IEEE 802.11
Wireless Access Method and Physical Layer Specification

Title: Revised MAC Frame Formats

Abstract: This paper proposes to revise the frame formats for the 802.11 MAC.

Figure 4-2: Frame Control Field

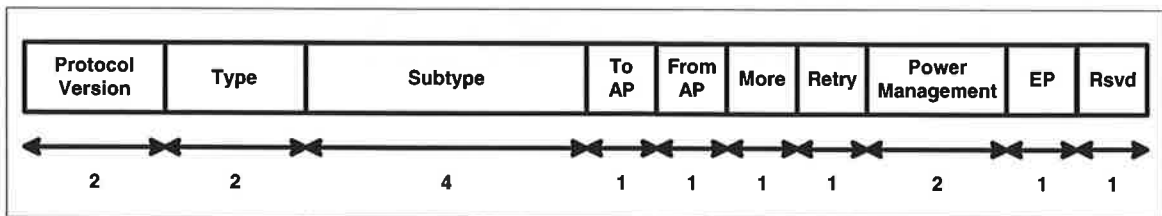
The Frame Control field shall consist of the following subfields: Protocol Version, Type, Subtype, To AP, From AP, More, Retry, Elements Present, Power Management, ~~CF ACK~~, ~~CF Poll~~ and ~~Elements Present~~. The remaining subfields in the Frame Control field are reserved. All reserved bits and fields shall be sent as '0'. Reserved bits and fields shall be ignored on reception.

Figure 4-xx: DATA Frame

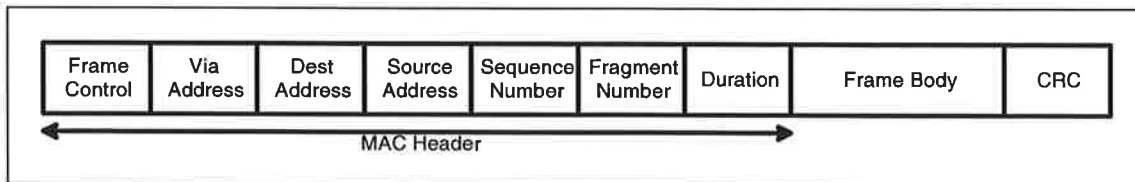
- 1) If the station is an AP or is a member of an infrastructure LAN, the Via Address shall be the address of the AP.
- 2) If the station is a member of an ad hoc LAN, the Via Address shall be the the BSS ID of the ad hoc LAN ~~address of the station transmitting the frame.~~

Figure 4-xx: Management Frame Format

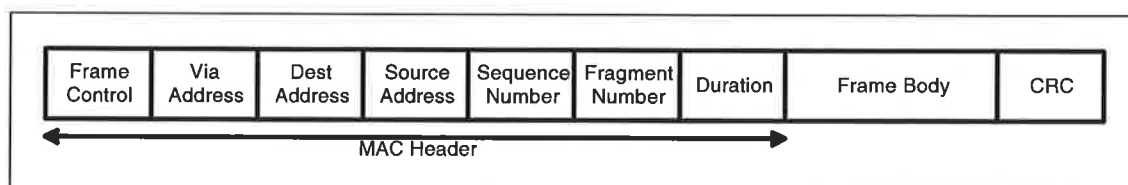
- 1) If the station is an AP or is in an infrastructure LAN, the Via Address shall be the address of the AP.
- 2) If the station is in an ad hoc LAN, the Via Address shall be the the the BSS ID of the ad hoc LAN ~~address of the station transmitting the frame.~~
